Access Compliance Report Public Rights-of-Way (Curb Ramps)

Main Street: SWIDLER_PL Cross Street: LA_VETA_AVE Location: SW

ADA ID: RPRK220222202841 Ramp Type: Type 1 - Perpendicular Diagonal Initial Pass/Fail: Fail Overall Compliance: No Severity Score: 2

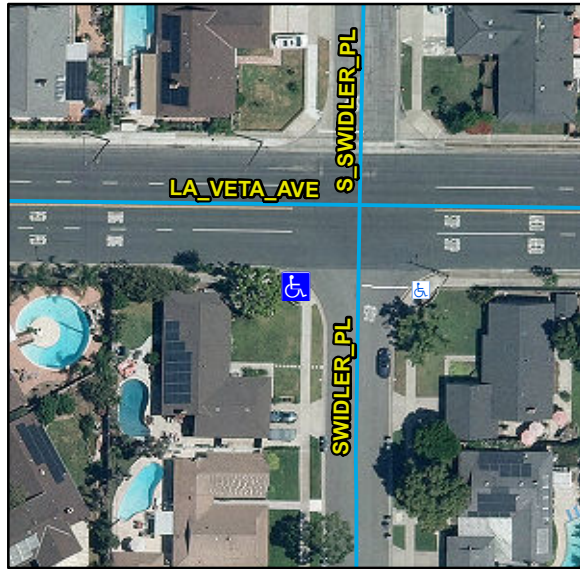
Compliance	Description	Data	Compliance	Description	Data
N/A	Ramp Length (in)	78	N/A	Flare Type LT	
Yes	Ramp Width (in)	48			N/A
Yes	Ramp Run Slope (%)	8.3	N/A	Flare Slope LT (%)	N/A
No	Ramp Cross Slope (%)	4.9	N/A	Flare Traversable LT	N/A
N/A	Landing Present	N/A	N/A	Flare Type RT	
N/A	Landing Length (in)	N/A			N/A
N/A	Landing Width (in)	N/A	N/A	Flare Slope RT (%)	N/A
N/A	Landing Run Slope (%)	N/A	N/A	Flare Traversable RT	N/A
N/A	Landing Cross Slope (%)	N/A	N/A	DWS Provided	N/A
N/A	Landing Movement Obstructed?	N/A	N/A	DWS Contrast	N/A
	Landing Movement Type	N/A	N/A	DWS Length (in)	N/A
N/A	Landing Shared	N/A	N/A	DWS Full Width	N/A
N/A	Clear Space	No	N/A	DWS Offset Left (in)	N/A
N/A	Clear Space To Crosswalk (in)	N/A	N/A	DWS Offset Right (in)	N/A
N/A	Marked Crosswalk 1	No	N/A	Marked Crosswalk 2	No
	Crossing 1 Direction	E		Crossing 2 Direction	N
	Marked Crosswalk 1 Width (in)	N/A		Marked Crosswalk 2 Width (in)	N/A

Remove & Replace Curb Ramp With Two New Directional Ramps or Equivalent.
